SERVICE BULLETIN

M-1130

RECALL CODE 0107 - 2002 FXDWG³ REAR BRAKE LINE

Figure 1. Rear Brake Line

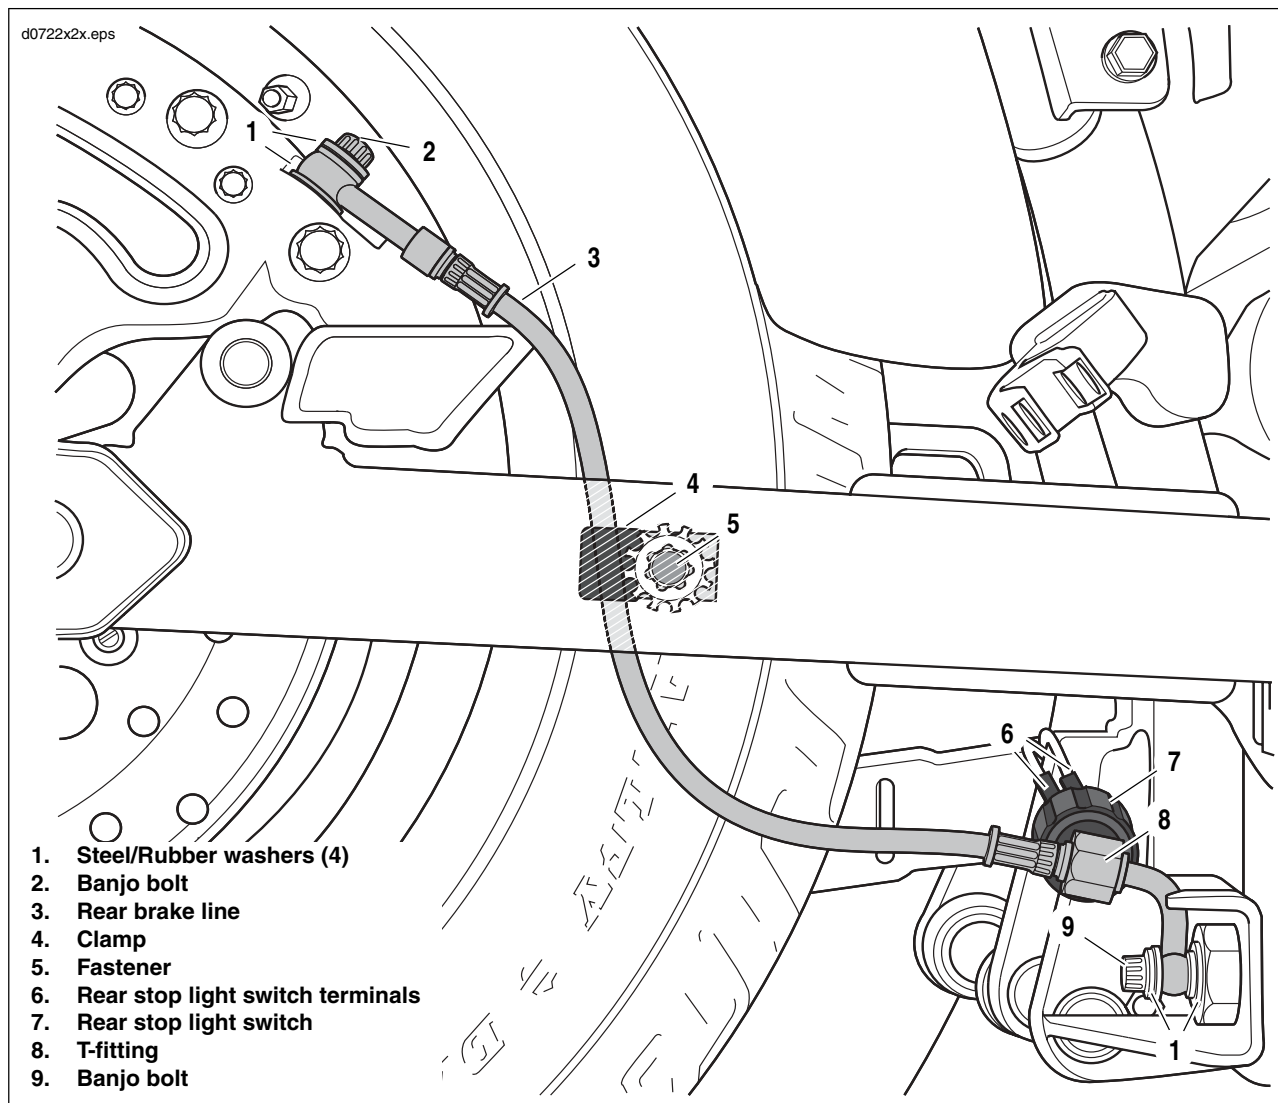
As recently advised in ML-379, Harley-Davidson has learned that there is a safety defect related to the braided rear brake line on 2002 FXDWG³ Wide Glide motorcycles. The rear brake line can fracture internally causing loss of rear brake fluid. The loss of rear brake fluid can cause the loss of rear brake function, possibly without warning, and could cause an accident.

1. See Figure 1. Remove two terminals (6) from rear stop light switch (7).
2. Remove the master cylinder banjo bolt (9) and both steel/rubber washers (1) to detach rear brake line (3) from master cylinder. Discard washers.
3. Remove fastener (5), clamp (4) and lockwasher securing rear brake line to rear fork.
4. Remove the banjo bolt (2) and both steel/rubber washers (1) to detach rear brake line from brake caliper. Discard washers.
5. Using a 1-1/16 in. open end wrench, remove stop light switch from T-fitting (8).

6. Coat threads of stop light switch with Loctite Pipe Sealant with Teflon (PST).
7. Install rear stop light switch to T-fitting on **new** brake line.
8. Tighten switch to 96-120 **in-lbs** (10.8-13.6 Nm).

9. Lubricate **new** steel/rubber washers with D.O.T. 5 SILICONE BRAKE FLUID.
10. Install **new** brake line to rear brake caliper using banjo bolt and **new** steel/rubber washers. Position brake line and tighten banjo bolt to 17-22 ft-lbs (23.0-29.8 Nm).
11. Install **new** brake line to rear master cylinder using banjo bolt and **new** steel/rubber washers. Position brake line and tighten banjo to 17-22 ft-lbs (23.0-29.8 Nm).

12. Install clamp on brake line with loop of clamp facing **rear** of motorcycle.

13. Install fastener in clamp. Place lockwasher onto fastener. Tighten fastener to 25-45 **in-lbs** (2.8-5.0 Nm).
14. Connect two terminals to rear stop light switch.
15. Bleed brake system. See appropriate Service Manual.
